AGENDA
CITY OF MAPLEWOOD HERITAGE PRESERVATION COMMISSION
Thursday, December 8, 2022
7:00PM

RE: METRO Purple Line (formerly Rush Line) Bus Rapid Transit, Ramsey County, Minnesota; 30%
Plan Review, SHPO #2019-0958

Technical Memorandum: 30% Plan Review

Project Layout Sheet 6

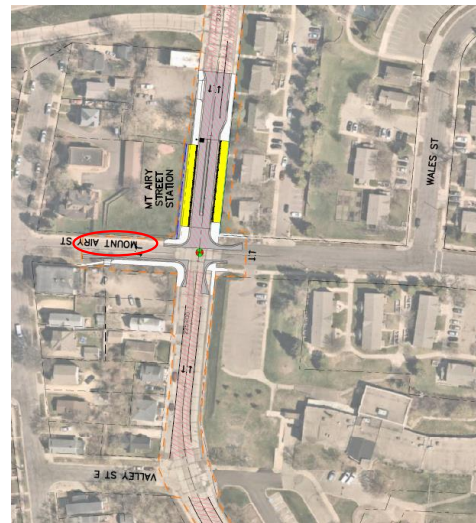
The southbound station platform was shifted approximately 30 feet further south. The City of Saint Paul requested the platform be shifted to allow for the trail crossing of Health Partners Drive to mimic what exists today. In addition, wider pedestrian ramps were included, construction limits on the south side of Phalen Boulevard were extended to the back of the parking lot curb, and a maintenance vehicle pull-off pad was added (Plan Sheets 86-87). There is a very small area not previously included in the archaeological study area boundaries (see red circle on layout sheet below). The 2020 archaeology report stated that along Phalen Boulevard the Project “will generally use existing roadway to Arcade, then RCRRA ROW to Johnson Parkway; station area heavily disturbed, ROW heavily disturbed; no survey recommended (page 77).” The small additional area within the 30% LOD is located within areas of previous disturbance from roadway and residential development. It is unlikely to contain intact, significant archaeological deposits and no additional archaeological fieldwork is recommended.

Project Layout Sheet 8

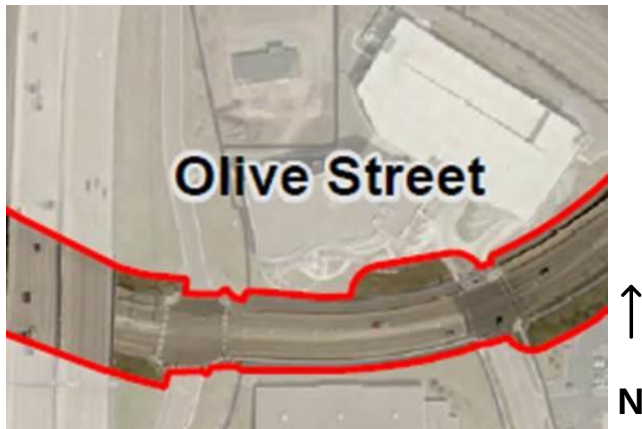
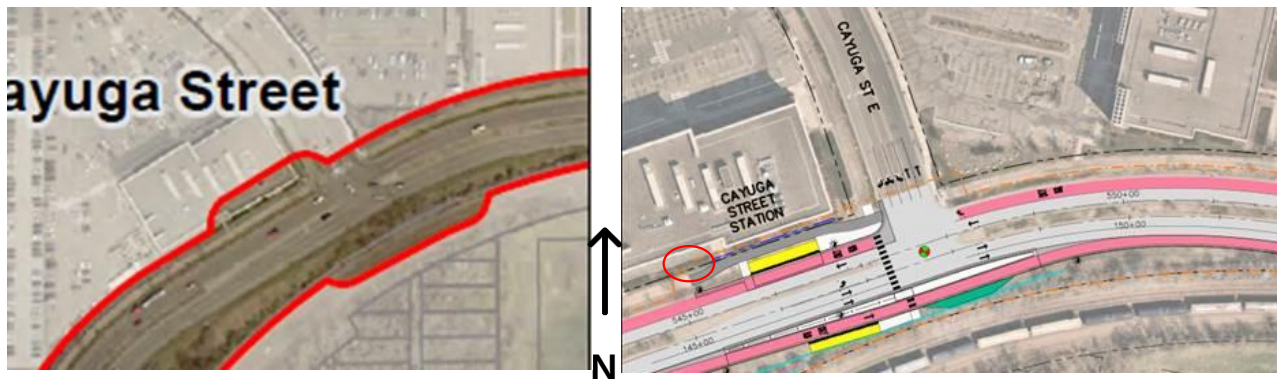
The northbound station was changed from a far side condition to a near side condition. The City of Saint Paul requested this change to eliminate a long second crosswalk on the east side of Cayuga Street and Phalen Boulevard. The City was concerned the signal timing required for pedestrians would significantly impact the existing traffic volumes. The decision was made through the DART. The southbound station shifted farther away from the intersection to allow crosswalks to work as they do today. In addition, retaining wall limits were refined and a maintenance vehicle pull-off was added (Plan Sheets 89-90). There is a small area not previously included in the archaeological study area boundaries (see red circle on layout sheet below). According to the 2020 archaeology report “station areas heavily disturbed; area along Payne Avenue heavily disturbed. Visual reconnaissance indicates locations of nine former railroad buildings at Cayuga Street; East St. Paul Station; E. St. Paul Roundhouse; and CStPM&O Roundhouse have been heavily disturbed by construction of Payne Avenue, modern buildings and installation of utilities. Low potential for intact deposits. No reconsideration per the Supplement to the [National Register Multiple Property Documentation Form] for Railroads in Minnesota, 1861-1956 (draft) warranted (Page 77).” The small additional area within the 30% LOD is located within areas of previous disturbance from roadway and residential development. It is unlikely to contain intact, significant archaeological deposits and no additional archaeological fieldwork is recommended.

FIGURE 1. BOUNDARY OF STPS&TF/OMAHA ROAD RAILROAD CORRIDOR HISTORIC DISTRICT IN BLUE NEAR THE ARCADE STREET RAMP.

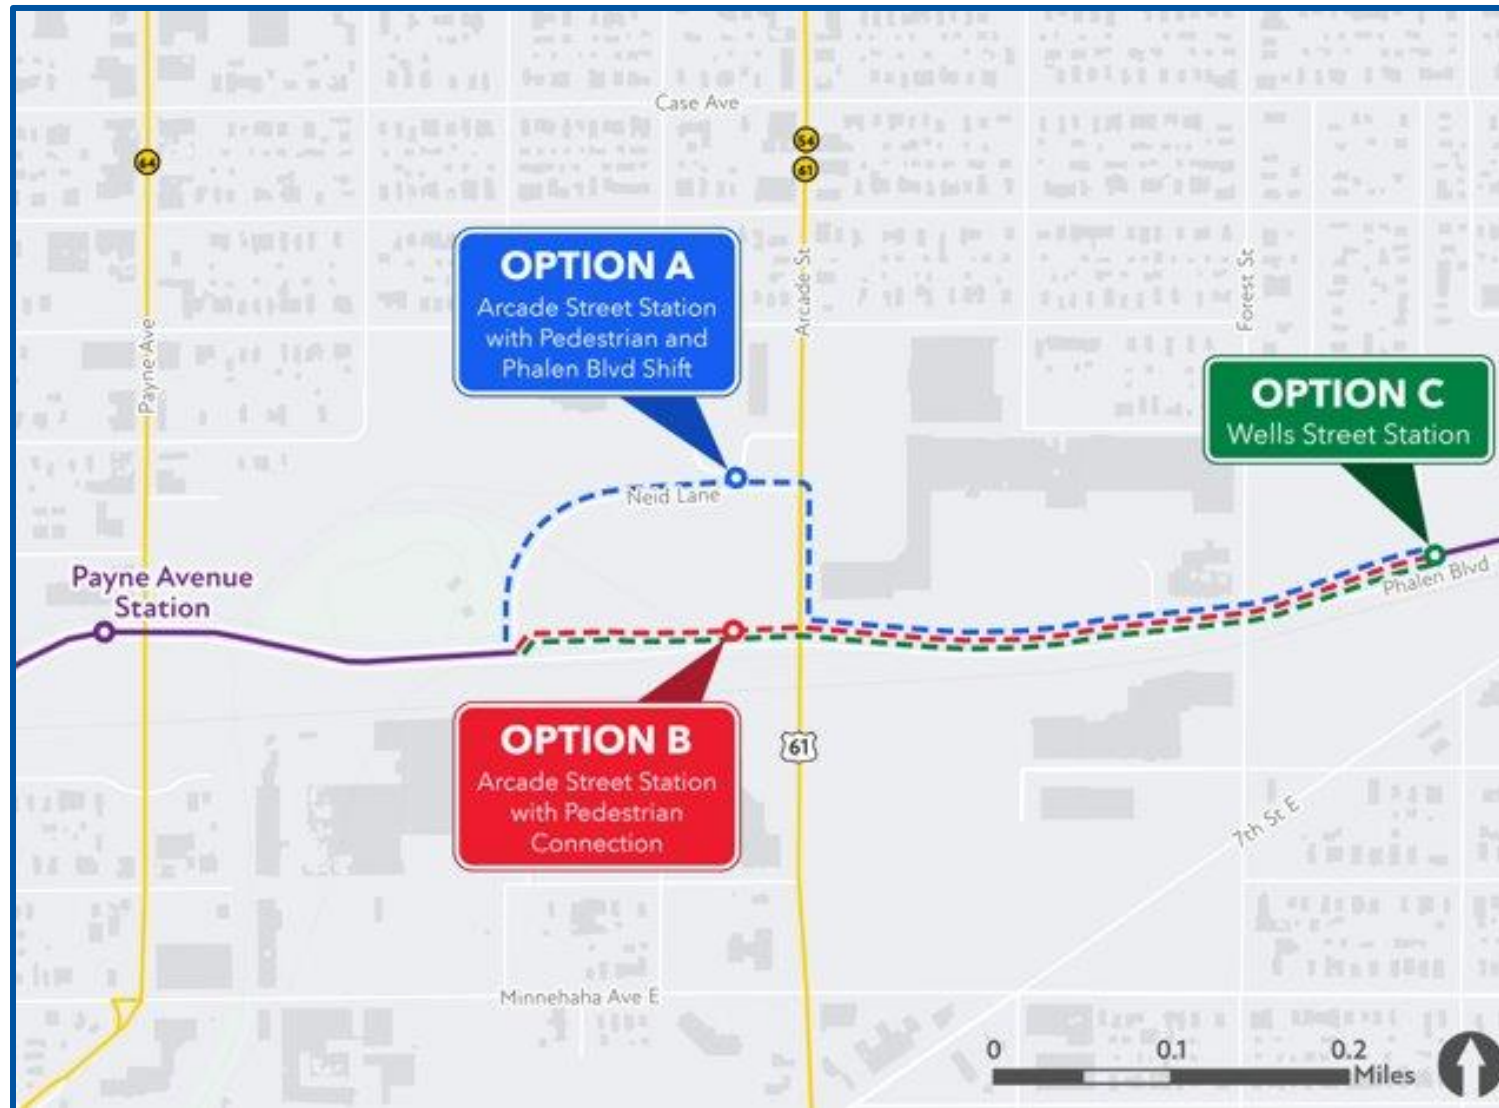
Three locations are now under consideration by the DART for the Arcade Street Station (see Figure 1 through Figure 5). Alternative location options were requested to mitigate concern of pedestrians/cyclists using the dedicated guideway ramp to access the Bruce Vento Trail from Arcade Street, and concern about winter maintenance of the grade of the ramp connection. Option A is the same proposed station location in the 15% Plans and includes minor realignment of the Phalen Boulevard ramp and pedestrian connections to the Bruce Vento Trail (Figure 3). Option B is in the open area north of Phalen Boulevard, west of Arcade Street, and east and south of Neid Lane (Figure 4). Option C is at Wells Street on the north side of Phalen Boulevard (Figure 5).

All three options are located within the Project APE; therefore, no further architecture/history survey work is needed. The Options B and C are slightly outside of the LOD on the 15% plans. The 2020 archaeology report stated that along Phalen Boulevard, the Project “will generally use existing roadway to Arcade, then RCRRA ROW to Johnson Parkway; station area heavily disturbed, ROW heavily disturbed; no survey recommended (page 77).” The small additional area within the 30% LOD is located within areas of previous disturbance from roadway, railroad, and commercial development. The small areas are unlikely to contain intact, significant archaeological deposits and no additional archaeological fieldwork is recommended.

FIGURE 3. ARCADE STREET STATION ALTERNATIVE OPTION A.

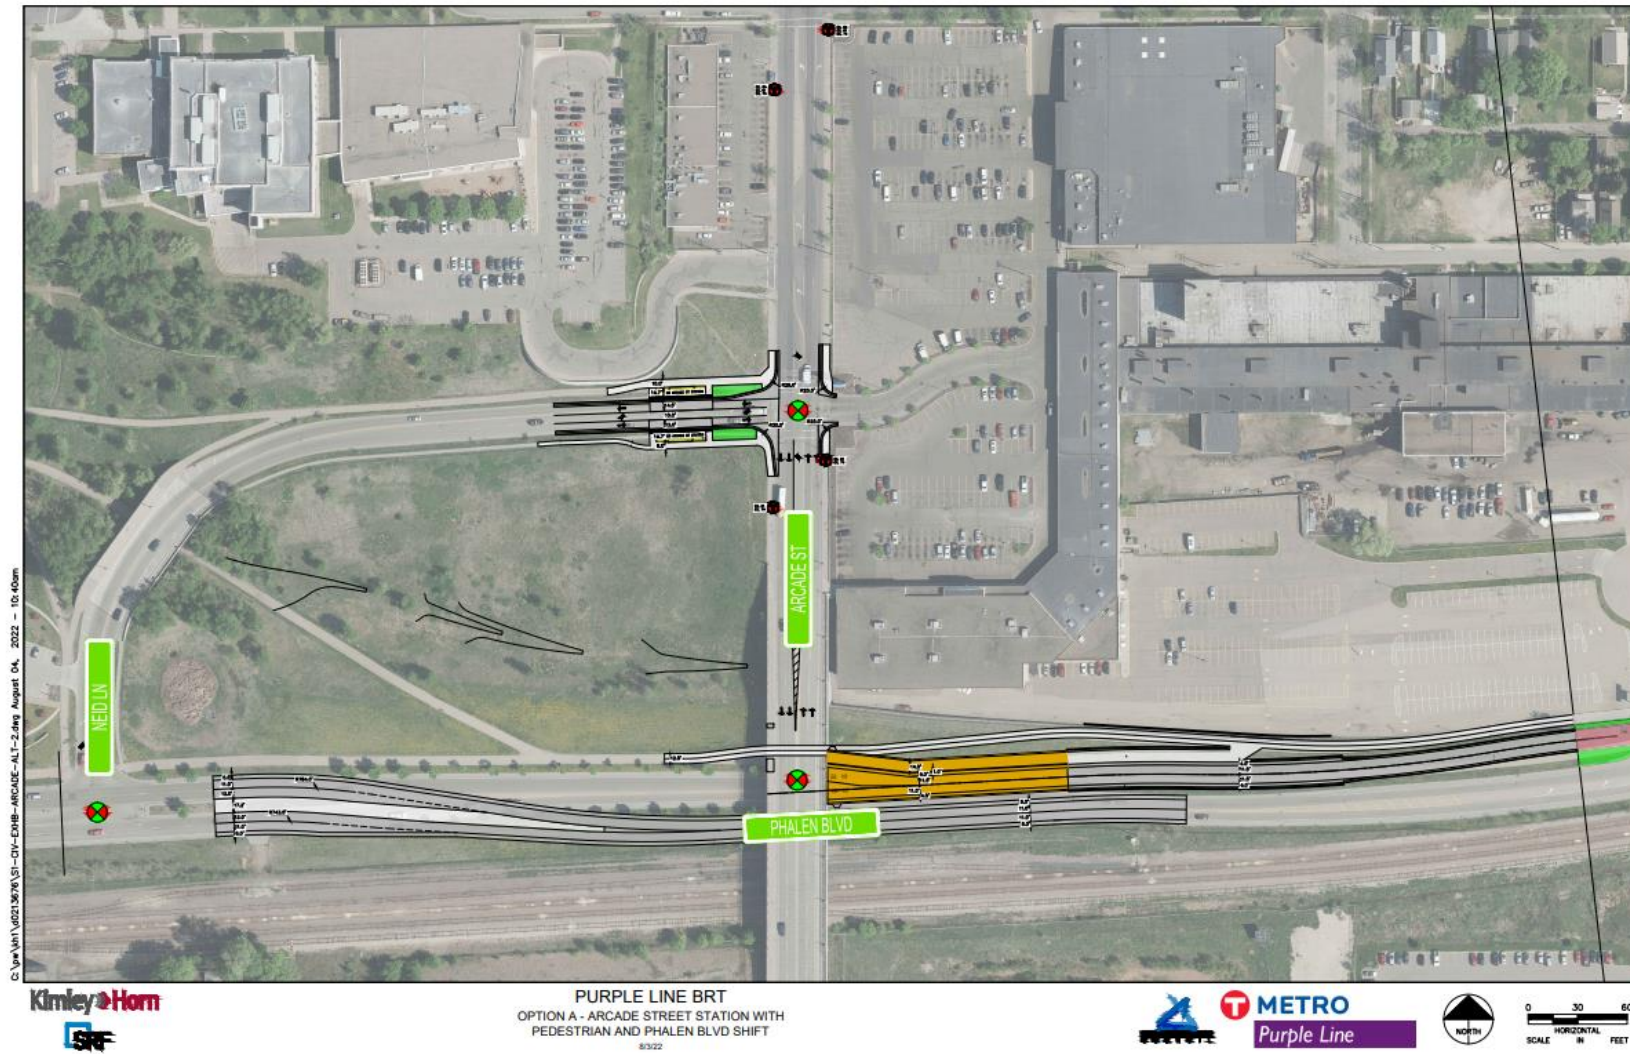
Further advancement of this station will occur in the 60% design phase. To receive consulting party comments on the new possible locations as per the MOA, which requires design considerations in relation to the StPS&TF/Omaha Road Railroad Historic District, the three proposed alternatives are included in this submittal and will be discussed at the consulting parties meeting to inform the 60% details (see Figure 1 through Figure 5).

Project Layout Sheet 14

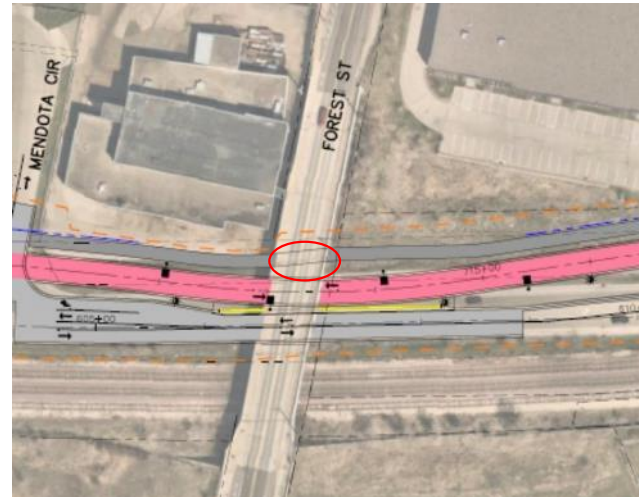
The trail route was bumped out in two locations for BMP and a pedestrian crossing was added, though these bump outs are within the previous LOD and archaeology study area (Plan Sheets 99-101). The 30% LOD at Forest Street were slightly extended to the west (see red circle on layout sheet below). The 2020 archaeology report stated that along Phalen Boulevard, the Project “will generally use existing roadway to Arcade, then RCRRRA ROW to Johnson Parkway; station area heavily disturbed, ROW heavily disturbed; no survey recommended (page 77).” The small additional area within the 30% LOD is located within areas of previous disturbance from roadway and residential development. It is unlikely to contain intact, significant archaeological deposits and no additional archaeological fieldwork is recommended.

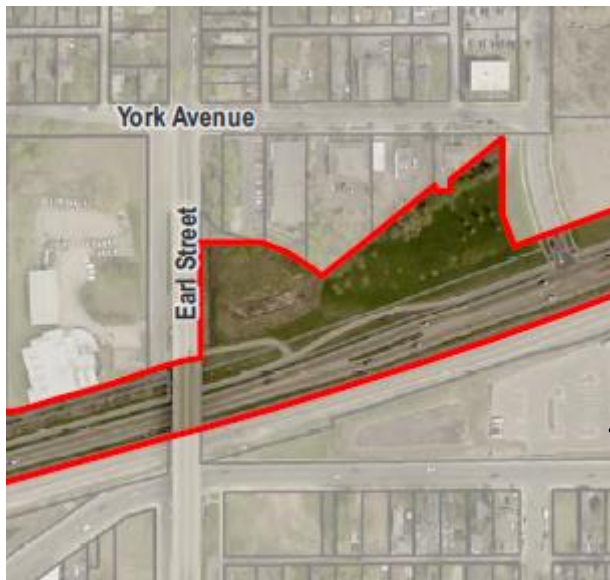
A retaining wall was added between the parking lot and trail due to grading constraints and to protect the parking lot. The station platforms were staggered, and the roadway section was revised to allow for enough space to incorporate access ramps between the stations and for pedestrians to have a single lane crossing. Pedestrian connection to Hmong Village was revised to be Americans with Disabilities Act (ADA) compliant and a maintenance pad pull-off added (Plan Sheet 107). The southern pedestrian connection to Magnolia was redesigned to save space and be more functional (Plan Sheet 109). Trail connection to the north was modified. However, all changes are within the previous LOD and archaeology pedestrian survey area; therefore, no further archaeological work is recommended.

Project Layout Sheet 15

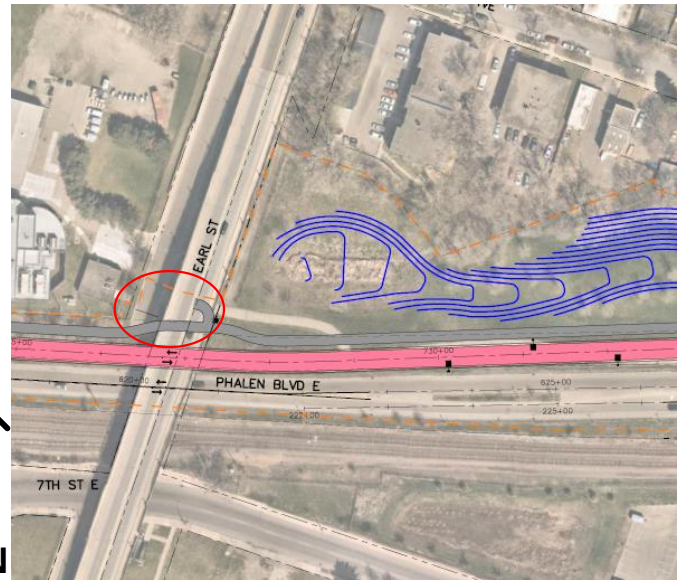
The 30% LOD at Earl Street were slightly extended to the west (see red circle on layout sheet below). The 2020 archaeology report stated that along Phalen Boulevard, the Project “will generally use existing

Project Layout Sheet 18

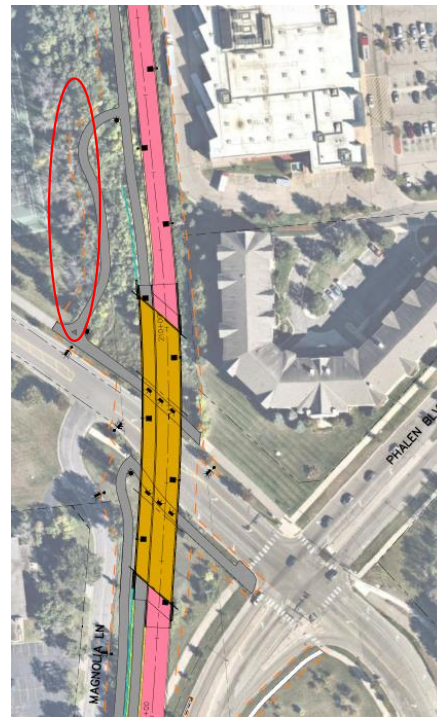
The Johnson Parkway Bridge profile was altered to meet 40 mph design speed and maintain critical clearance. A new trail connection on the north side of Johnson Parkway is slightly outside the 15% LODs and an existing retaining wall will be removed (see red circle below on Layout Sheet 18; Plan Sheet 110). According to the 2020 Archaeology Report “rail connection to Phalen Park on St. Paul Park property – this area was originally part of Lake Phalen; fill deposited to fill in lake; no potential for prehistoric surficial deposits. No survey recommended.” It is unlikely to contain intact, significant archaeological deposits; therefore, no additional archaeological fieldwork is recommended. See Stipulation V.A.ii: Trail Design in Phalen Park discussion below on the trail design. A design concept for the bridge has been develop, as discussed under Stipulation VI.A.iii: Johnson Parkway Bridge Area below for recommendation on if the proposed design meets the SOI Standards.

Project Layout Sheet 19

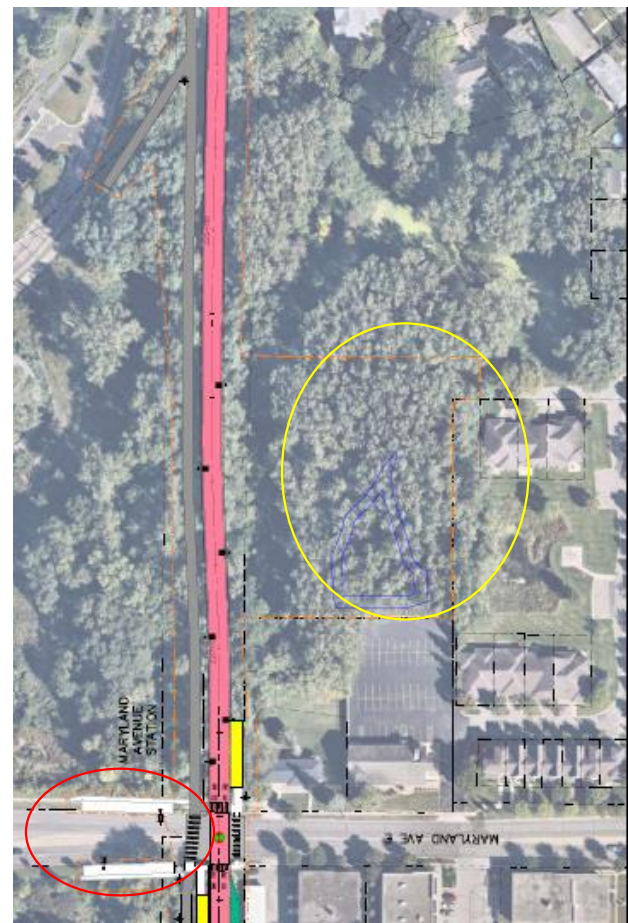
The Maryland Avenue Station platforms were moved back from the intersection to allow for improved grading and ADA design. The bus pads on Maryland Avenue have been lengthened for local bus queueing. A maintenance pad pull-off was added (Plan Sheet 110). There is a small area not previously included in the archaeological study area boundaries for the extended bus pads (see red circle on layout sheet below). The bus extension areas are located within previously disturbed roadways and the area is unlikely to contain intact, significant archaeological deposits. The area within the yellow circle is located outside the 15% LOD. Based on the 2020 archaeological report and historic aerial (1940), the area “was originally part of Lake Phalen; fill deposited to fill in lake; no potential for prehistoric surficial deposits. No survey recommended (Page 77).” It is unlikely to contain intact, significant archaeological deposits; therefore, no additional archaeological fieldwork is recommended.

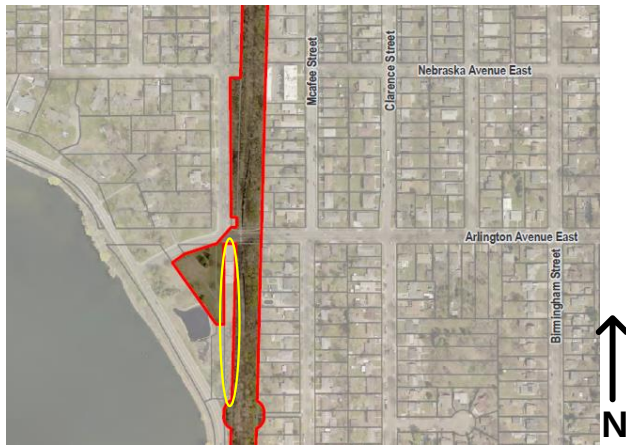
The McAfee Bridge was proposed to be rehabilitated at the 15% plan stage but is now proposed to be replaced. As a non-reinforced-concrete bridge for which no plan sets exist, it is problematic for engineers to determine the bridge's load-carrying capacity for the Purple Line BRT, which would run on top of it. As such, there is no demonstrable way to repair the bridge with sufficient documentation that it meets load requirements. In addition, the revised typical section includes a wall between guideway and trail (Plan Sheets 111-112). All changes are within the previous LOD and archaeology study area; therefore, no further archaeological fieldwork is recommended. The decision was made through the DART. See the Stipulation XI: Additional Assessment of Effects discussion below for review of this change for additional adverse effects to the LS&M Railroad Corridor Historic District.

As per the terms of Stipulation XII, the new bridge should be designed in accordance with the SOI Standards to the extent possible to minimize additional effects. The 30% plans also reduce the LOD to other portions to the LS&M Railroad Corridor Historic District, namely at the Arlington bridge crossing, which will allow for more of the railroad bed to remain intact.

FIGURE 6. PROPOSED DESIGN FOR THE WEAVER TRAIL UNDERPASS.

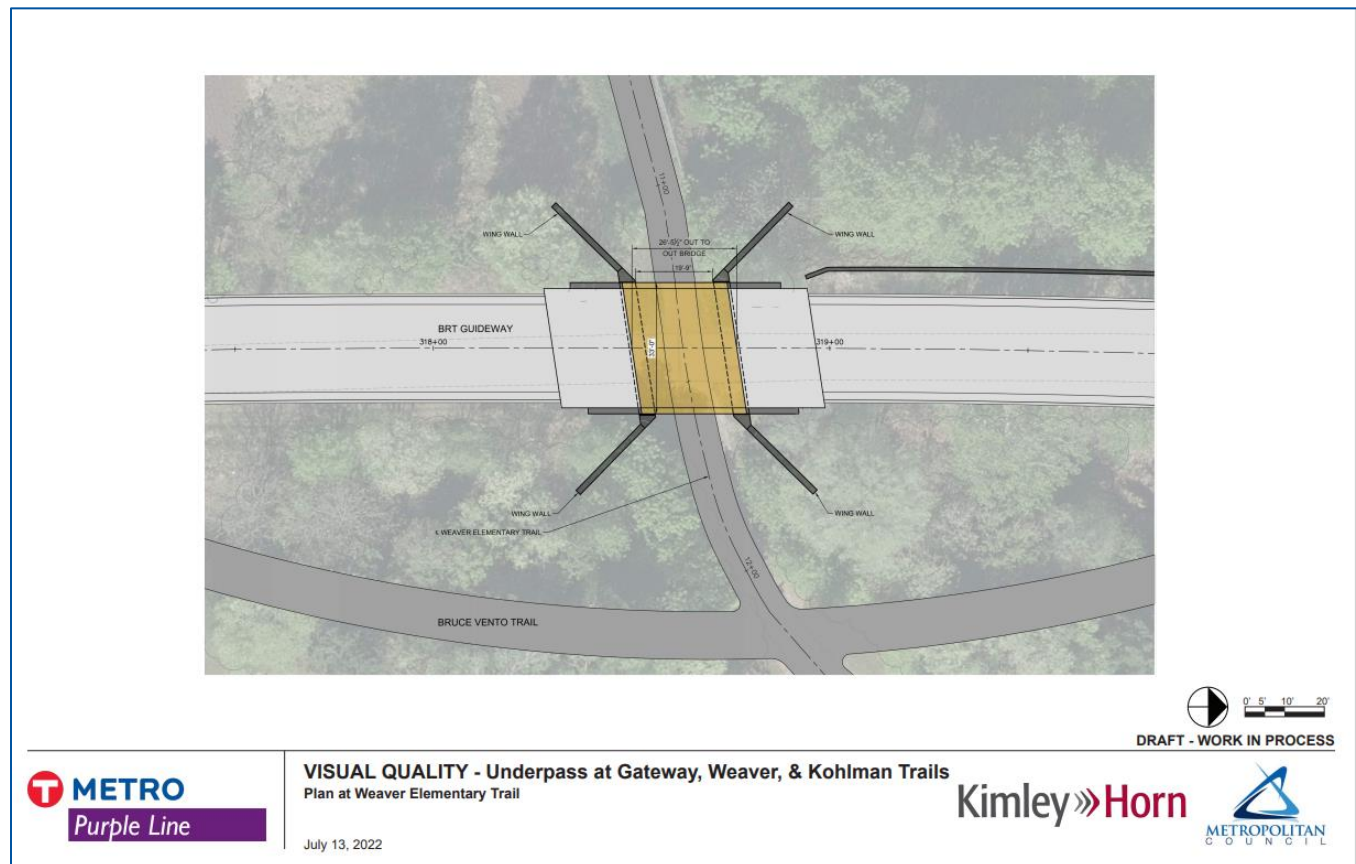
In addition, a bridge type has been selected (see Figure 6 and Plan Sheet B7 of B10) for the pedestrian underpass at Weaver Trail. The concrete beam bridge will have wingwalls instead of abutments, which minimizes physical elements in the space and allows for more vegetation, helping to avoid visual intrusion in the school's viewshed.

A concrete beam bridge with wingwalls is proposed to avoid the use of piers and abutments and to maximize the presence of vegetation at the crossing in the side slopes. (see Figure 6 and Plan Sheet B7 of B10). The plan sheet shows concrete wingwalls with limestone pattern. The Preservation Lead is working with the DART to on a simpler design for the concrete wingwalls in which they will be plain concrete with no design or pattern. Based on the 30% plans, there are two proposed retaining walls and a concrete barrier (Plan Sheet 125-126) in the defined review area. There are no stormwater BMPs in the defined review area.

The design of the underpass and retaining walls and concrete barrier near the Weaver Trail Underpass Area is under development and will be assessed at the 60% design stage, following input from consulting parties between the 30% and 60% plans.
